PRODUCT NOTICE # 4-16-10-1

HDMI Resistor Patch Instructions

ConnectCore Wi-i.MX51

Part Number	Description
55001445-02	ConnectCore Wi-i.MX51 module

Figure 1: Identify part number and hardware revision on label (top of module)

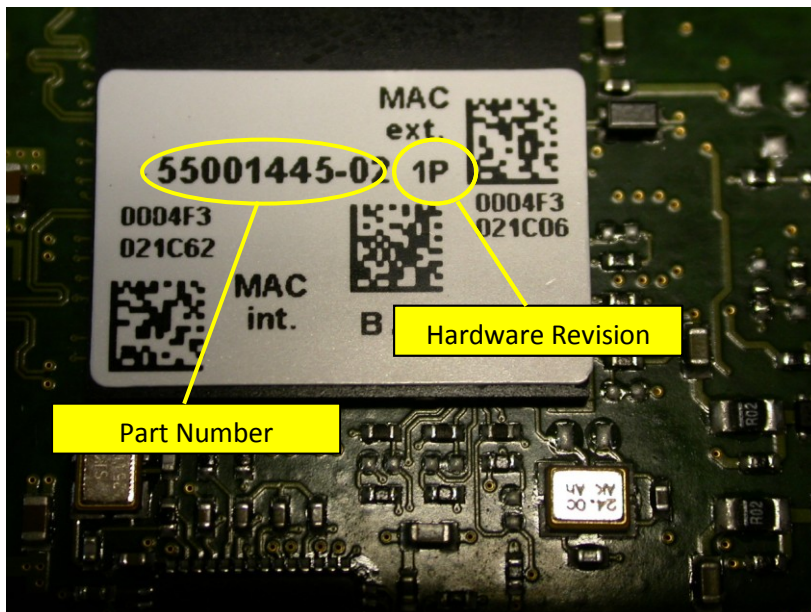
The issue applies to modules with Digi P/N **55001445-02** revision **1P** only.

Figure 2: Identify general area of resistor location (bottom of module)

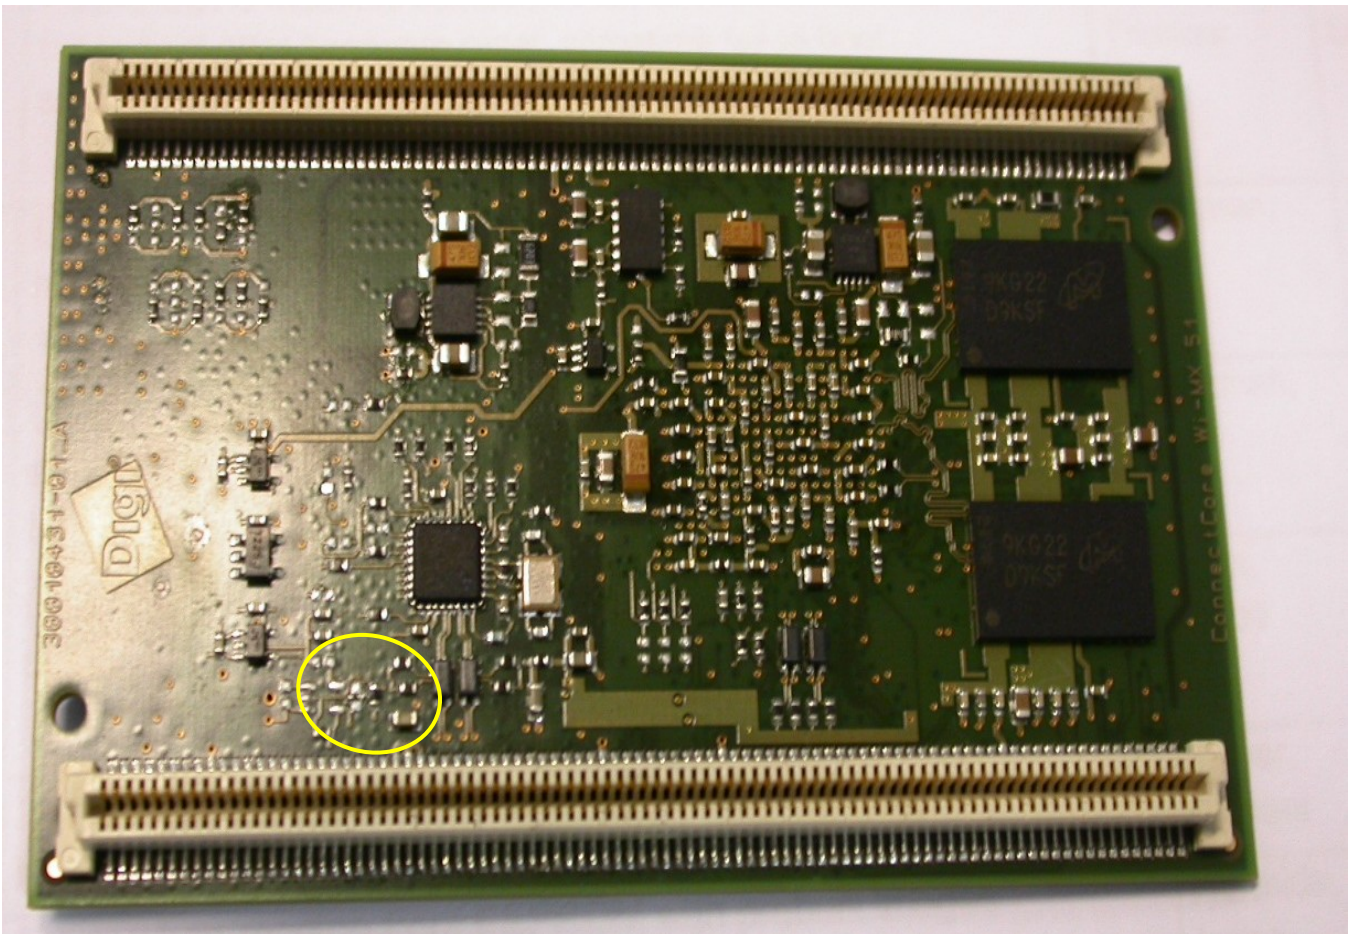
In order to aid in the visual inspection process and proper component depopulation, the close-up images provided below outline the location of the label indicating the Digi part number/revision, and the actual location of the resistor that needs to be depopulated.

Figure 3: Close-up of resistor (R99) to be removed

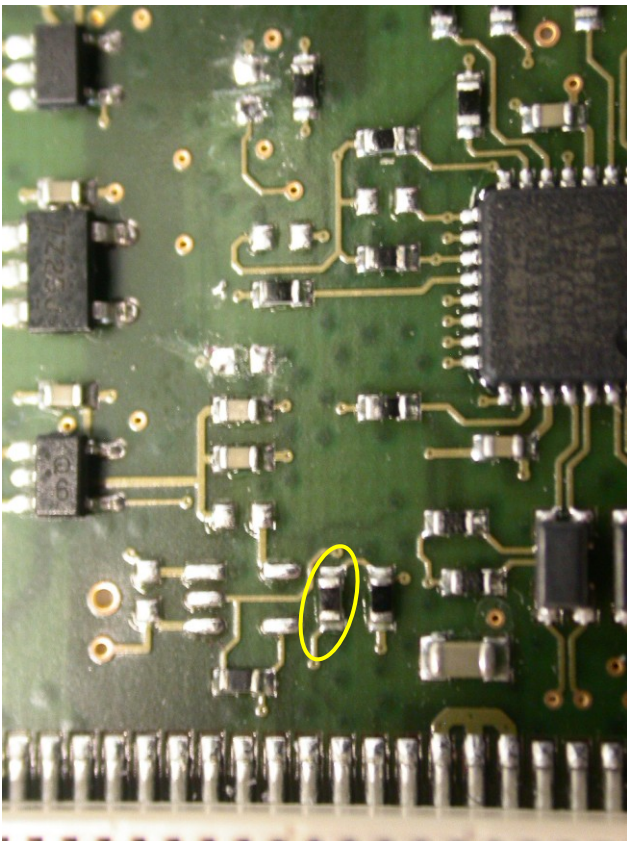
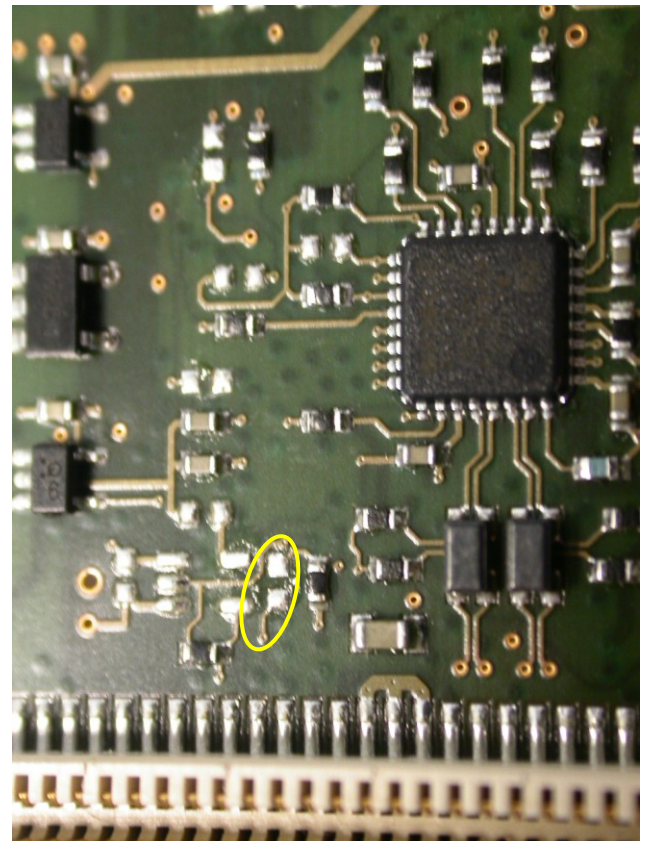
The 0R series resistor R99 must be depopulated in order to enable the HDMI interface on the development board.

Figure 4: Close-up after resistor depopulation
